RHODE ISLAND DEPARTMENT OF TRANSPORTATION

RHODE ISLAND CONTRACT NO.2019-CT-099

HSIP - Crosswalk & Sign Enhancements

NOTICE TO PROSPECTIVE BIDDERS

RRFBA AC-POWERED RAPID RECTANGULAR FLASHING BEACON (RRFB) - FRONT VIEW
NOT TO SCALE

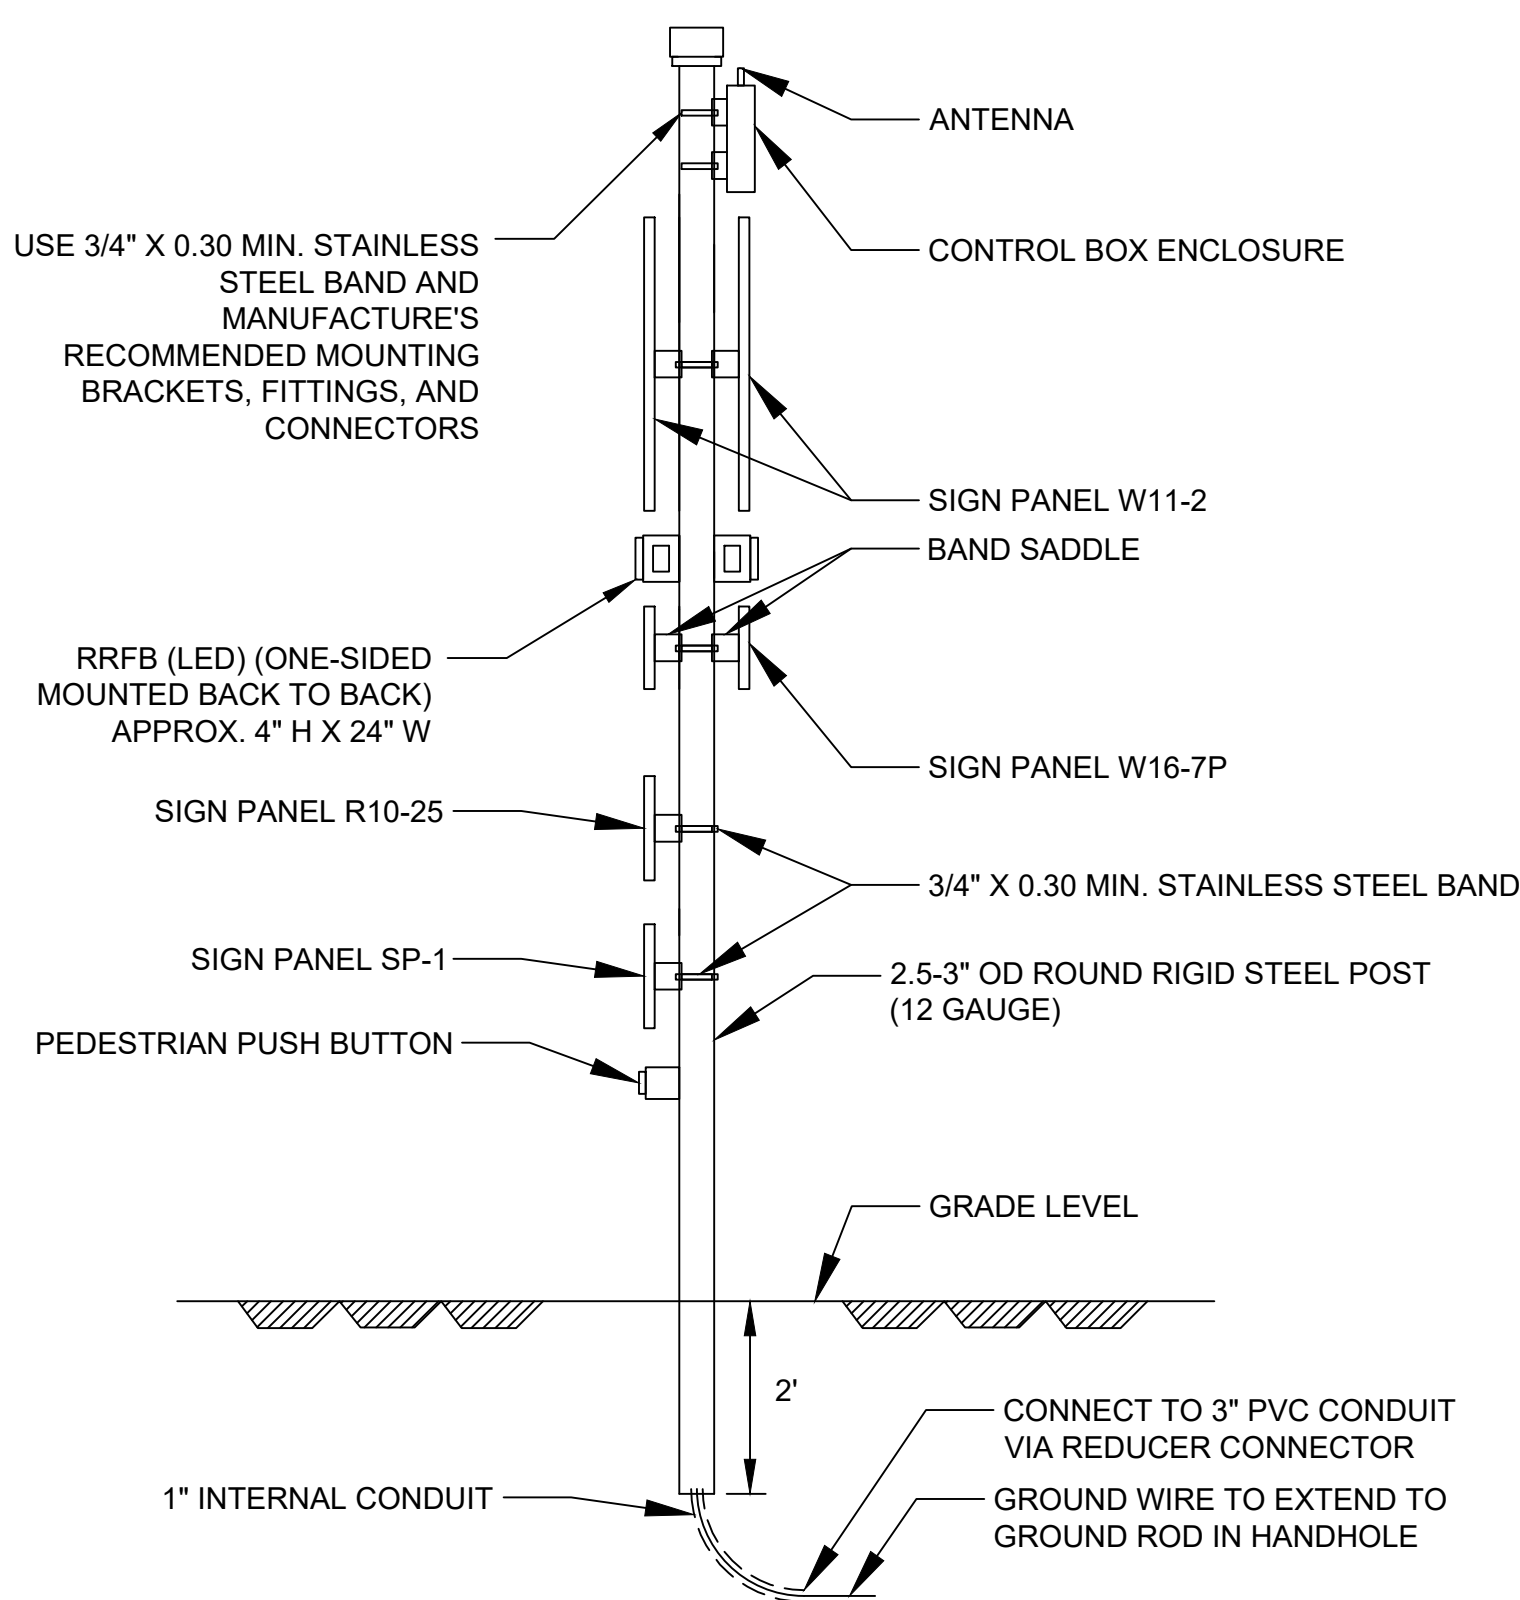
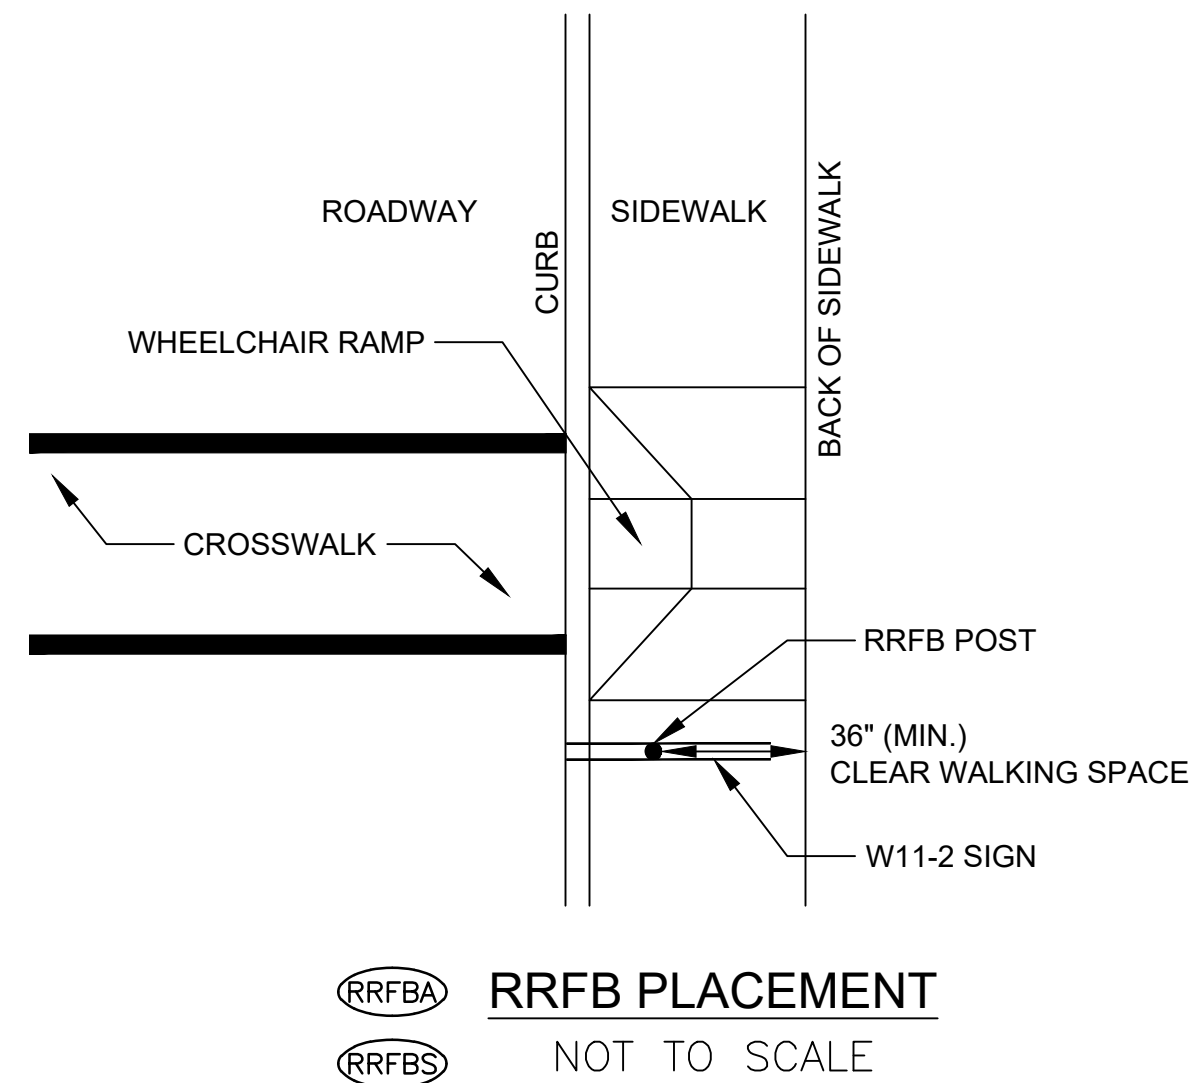
Delete Sheet No. 8 in its entirety and replace with Sheet No. 8 (R-1), attached to this Addendum No.1. The detail for Off-Center RRFB Sign Mounting was revised.

ii. Sheet 17, Traffic Signal Plan – Loc A-1

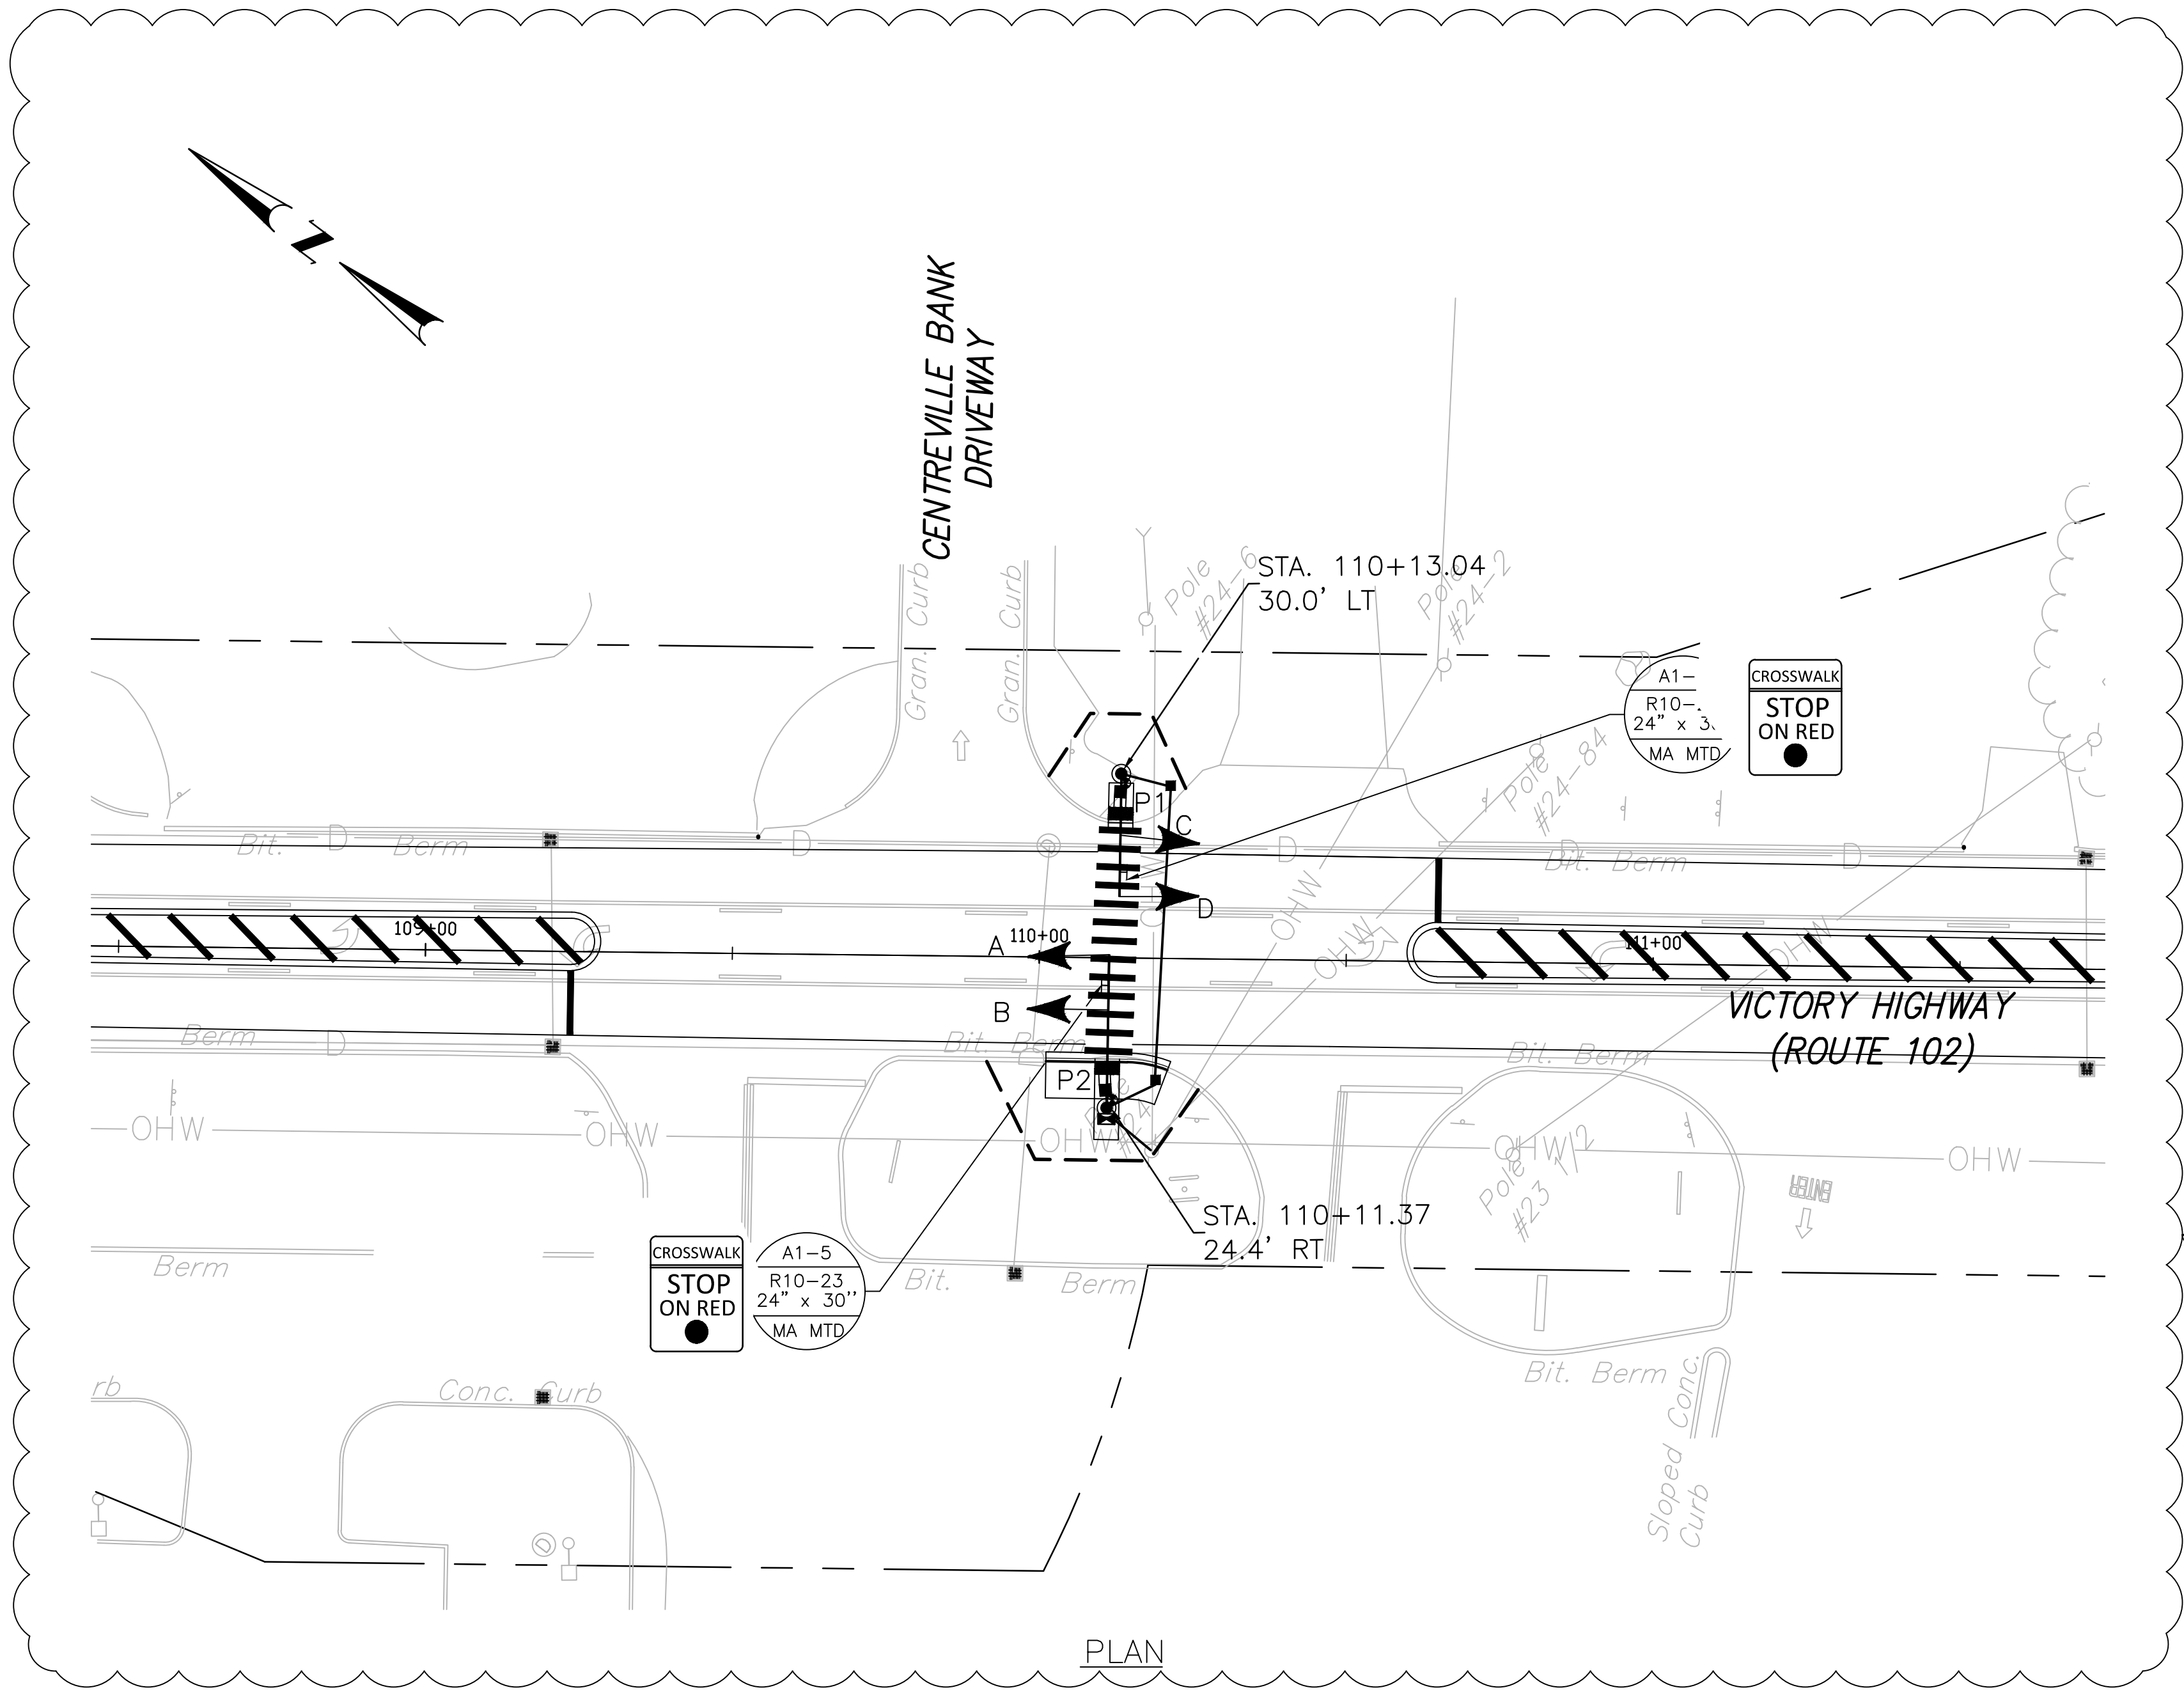
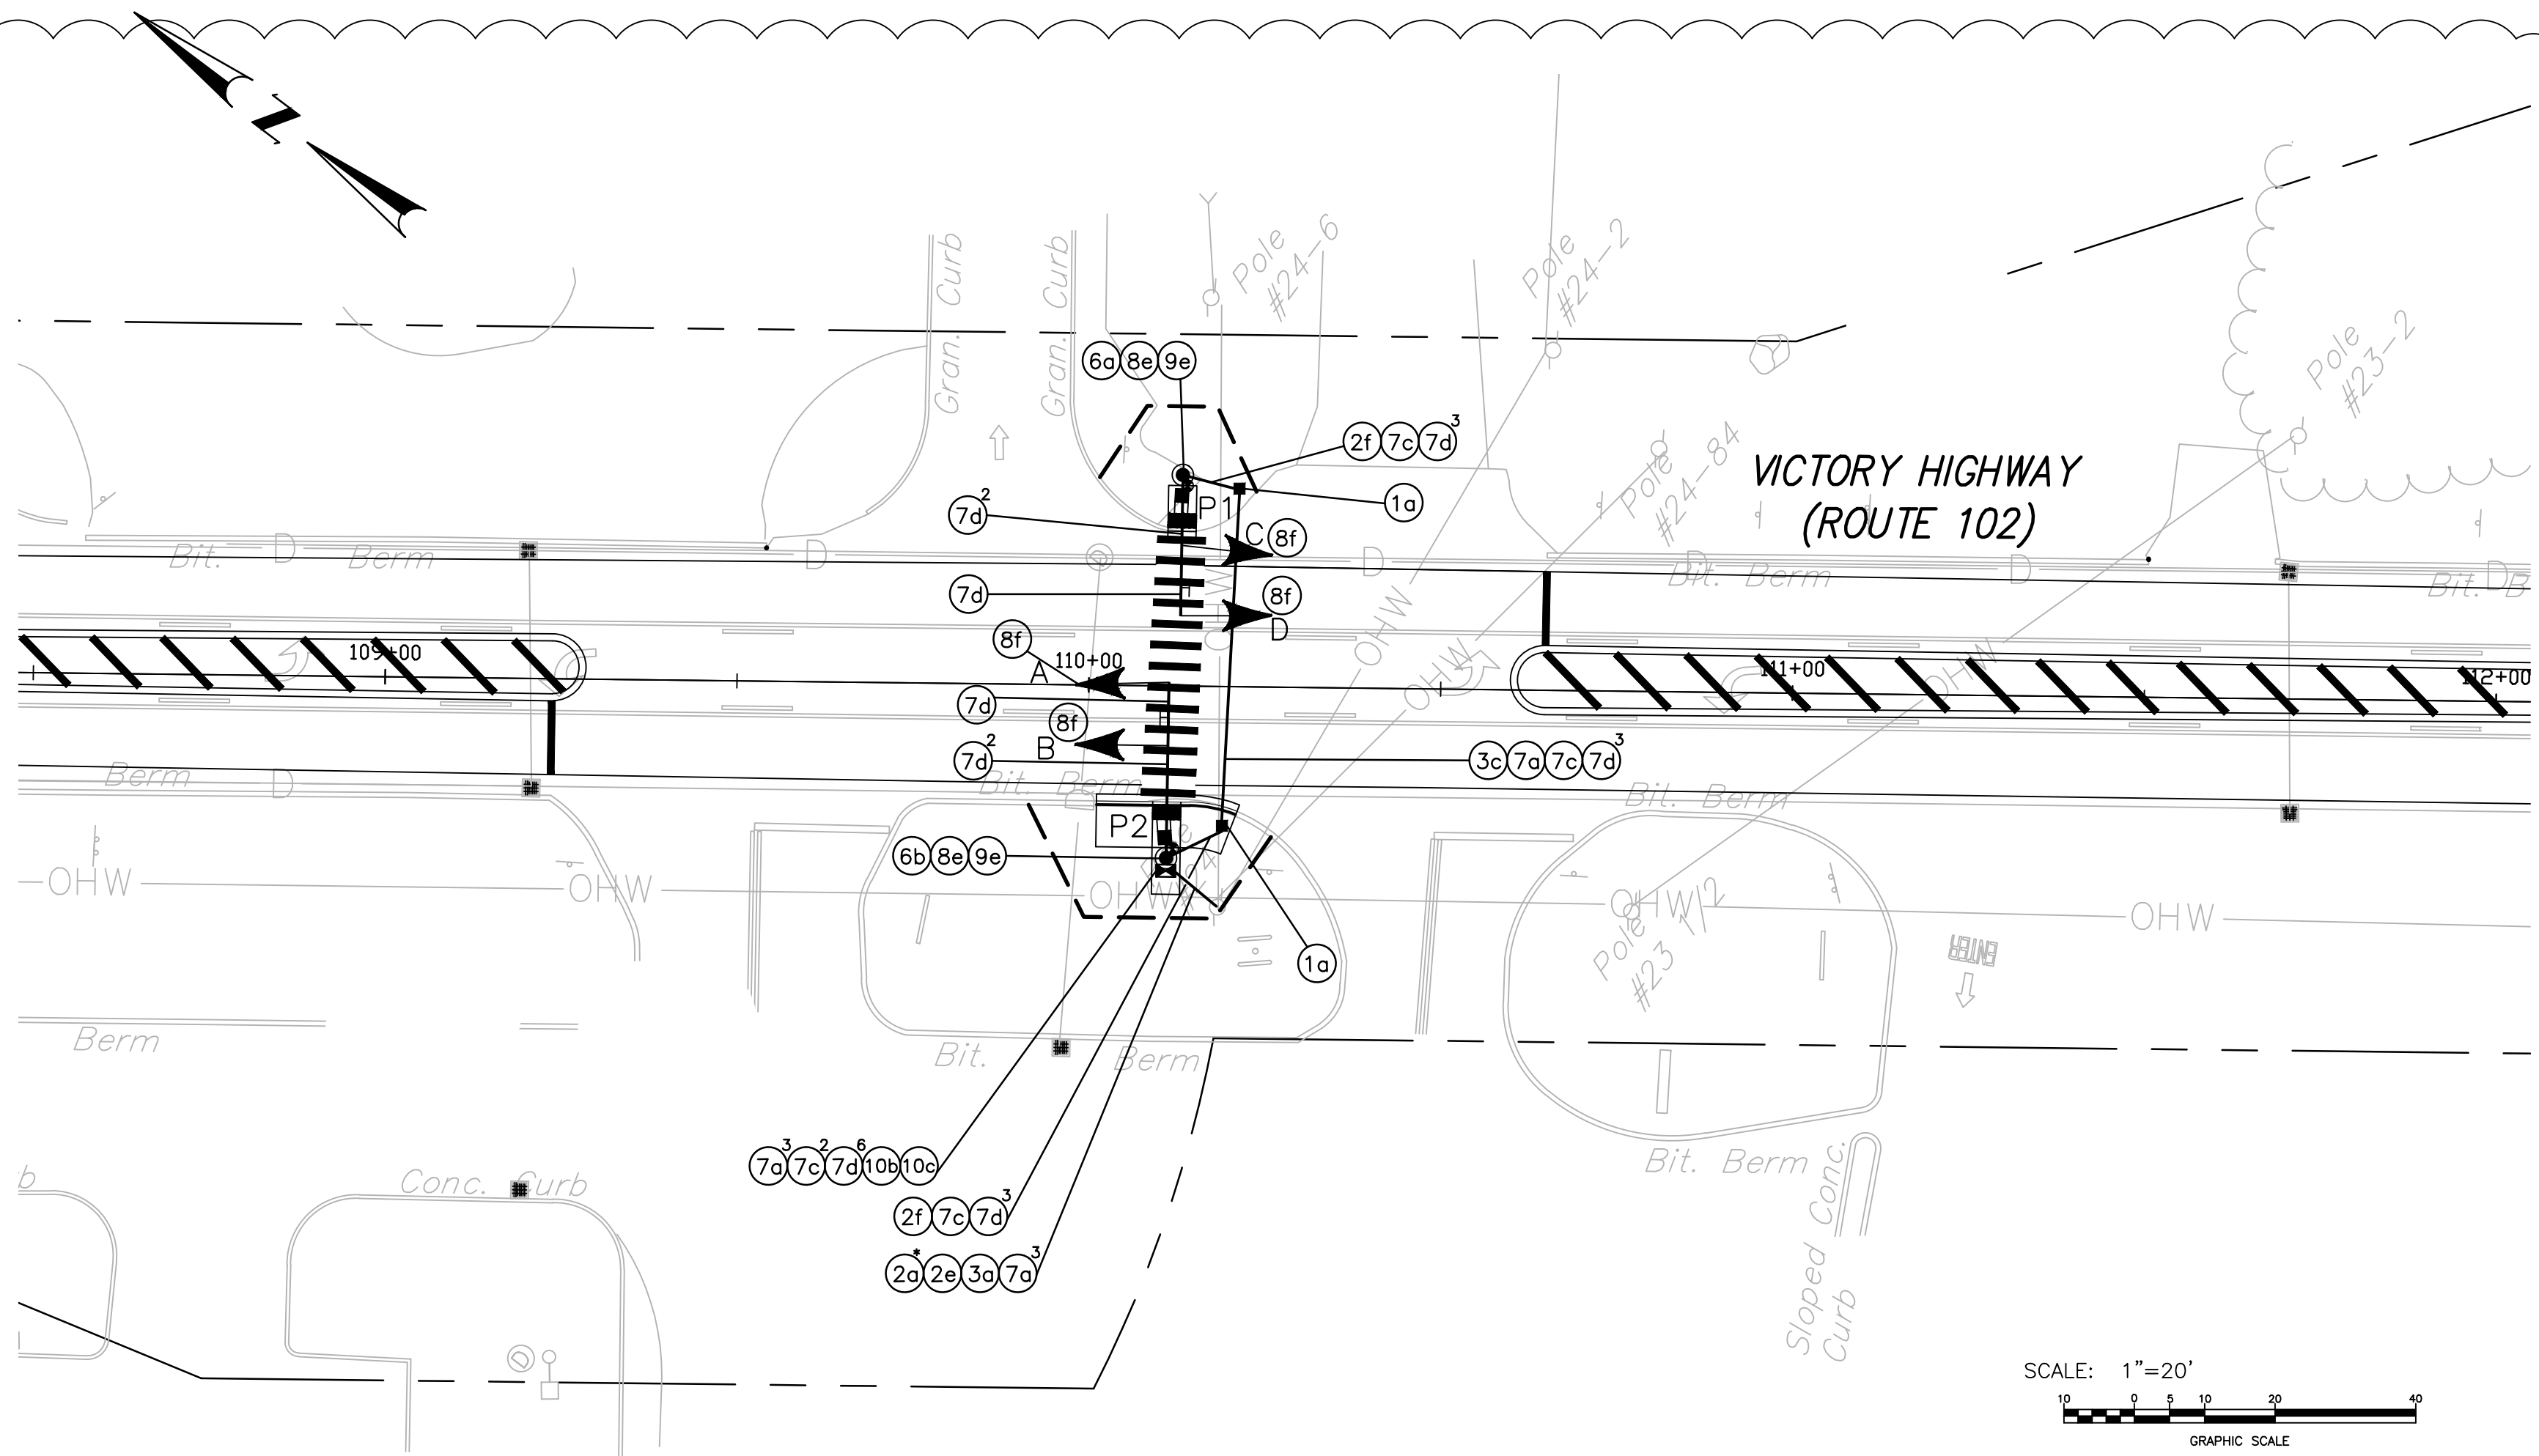
Delete Sheet No. 17 in its entirety and replace with Sheet No. 17 (R-1), attached to this Addendum No.1. The sheet was revised to show proposed pavement markings.
